STAFF RECOMMENDATION

NCPC File No. 6910

NATIONAL MALL AND MEMORIAL PARKS WAYFINDING AND SIGN PROGRAM - PEDESTRIAN GUIDES AND MAP KIOSKS

May 28, 2009

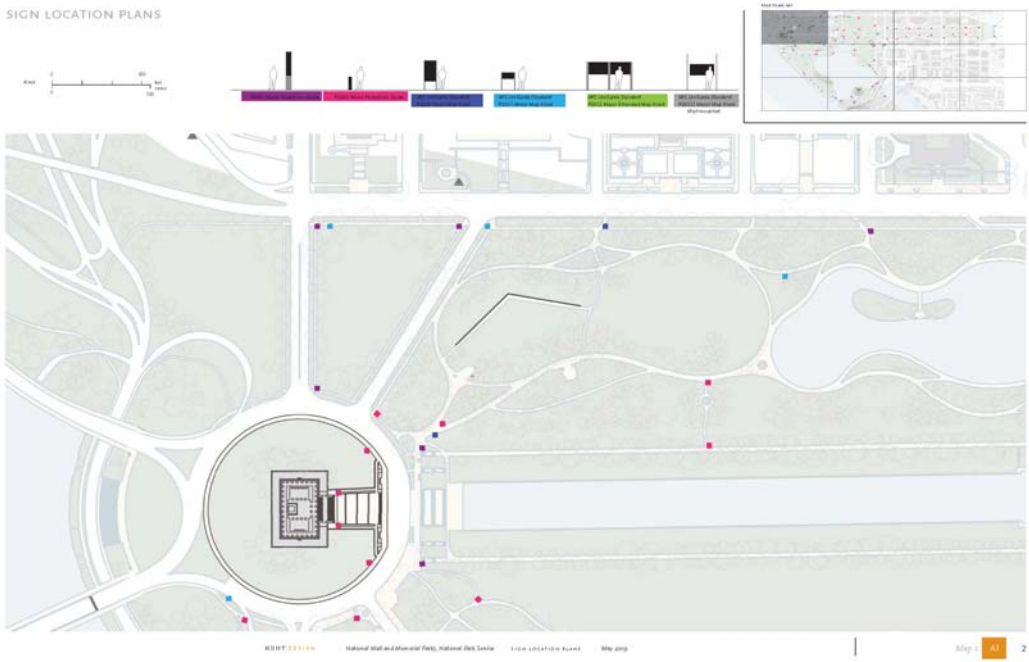
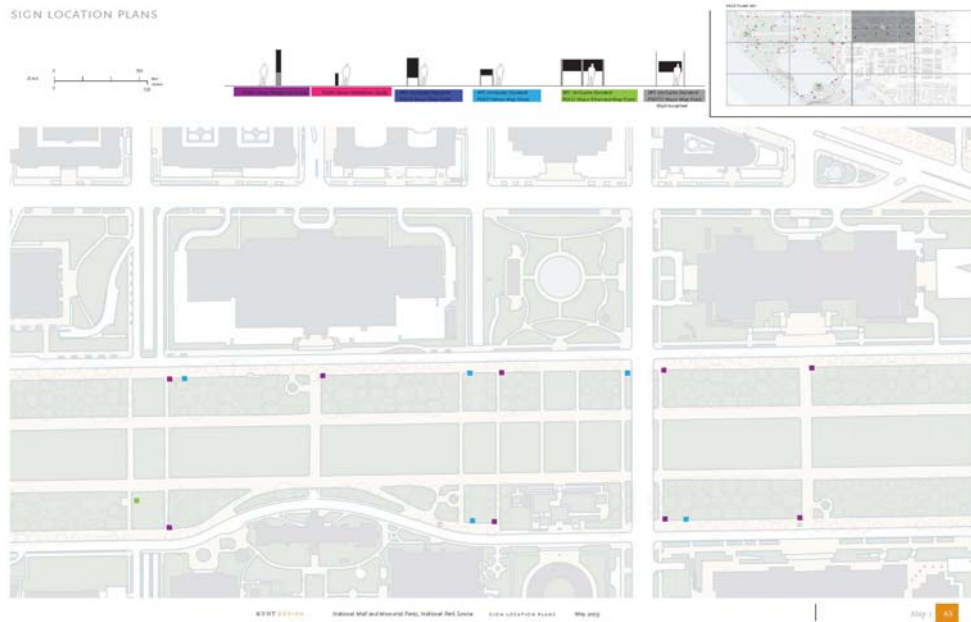
The D.C. State Historic Preservation Officer (DC SHPO) has determined that the undertaking will have *No Adverse Effect*, conditioned on field-checking final locations for pylons near memorials.

The DC SHPO, in its letter of March 9th, determined that the signs would have *No Adverse Effect* on the historic properties of the Mall provided that NPS: 1) consult further with the DC SHPO during the CFA and NCPC review processes regarding the final type, location and number of pedestrian guide pylons near the major monuments and memorials (noting concern for use of the tall pylons near the Washington Monument); 2) provide additional opportunities for public review and comment such as the National Mall Plan meeting forum; and 3) assess the potential for archaeological impacts for signage located outside of East and West Potomac Parks where the soil is not entirely composed primarily of fill.

The four sign types proposed in the current submission. The map includes visitor destinations on, near, and beyond the National Mall. The pylons will direct visitors to memorials and museums on the Mall, off-Mall destinations, and to Metrorail stations.

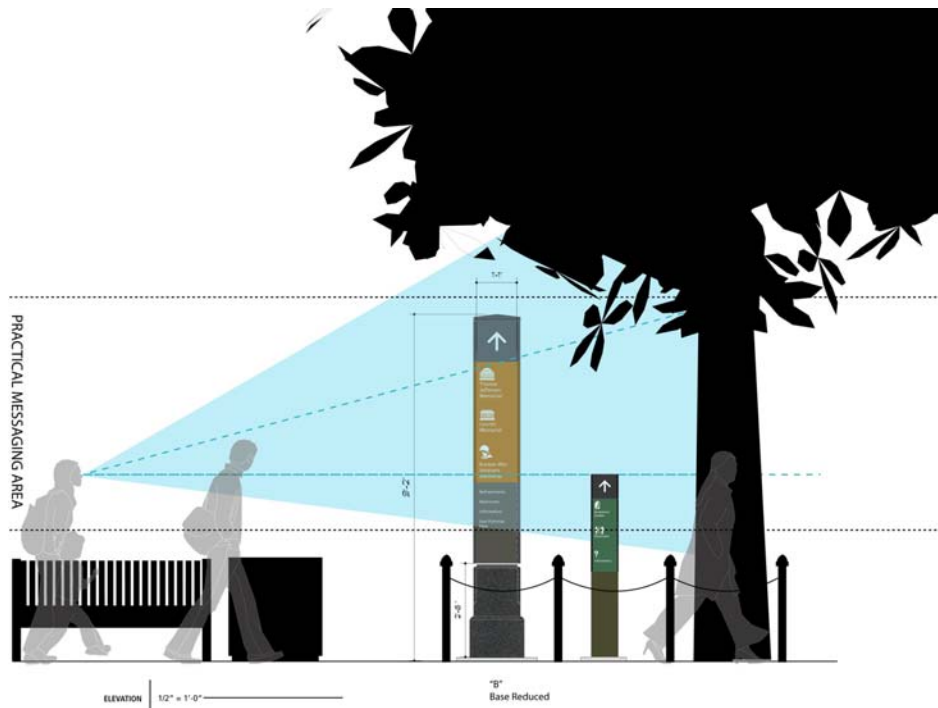
NPS is continuing to refine the form, height, and detailing of the pylon and to develop the color scheme for the tiles. *The staff recommends that the pylon form be simplified by eliminating the base and that it be fabricated at the revised height of 9'2".*

Staff supports the use of the four-sided pylon form for wayfinding at intersections. The pylons will usually be located near trees, and their tall, slender form will be more visually compatible than rectangular signs on posts with the trees. *The staff supports the use of a contemporary form rather than a historicized sign. The staff recommends that the profile of the granite base be simplified further by eliminating the base and that the 9'2" pylon be approved.*

Recommends, in the preparation of final site development plans, that the taller pylon form be simplified by eliminating the base and fabricated at the proposed revised height of 9’2”.
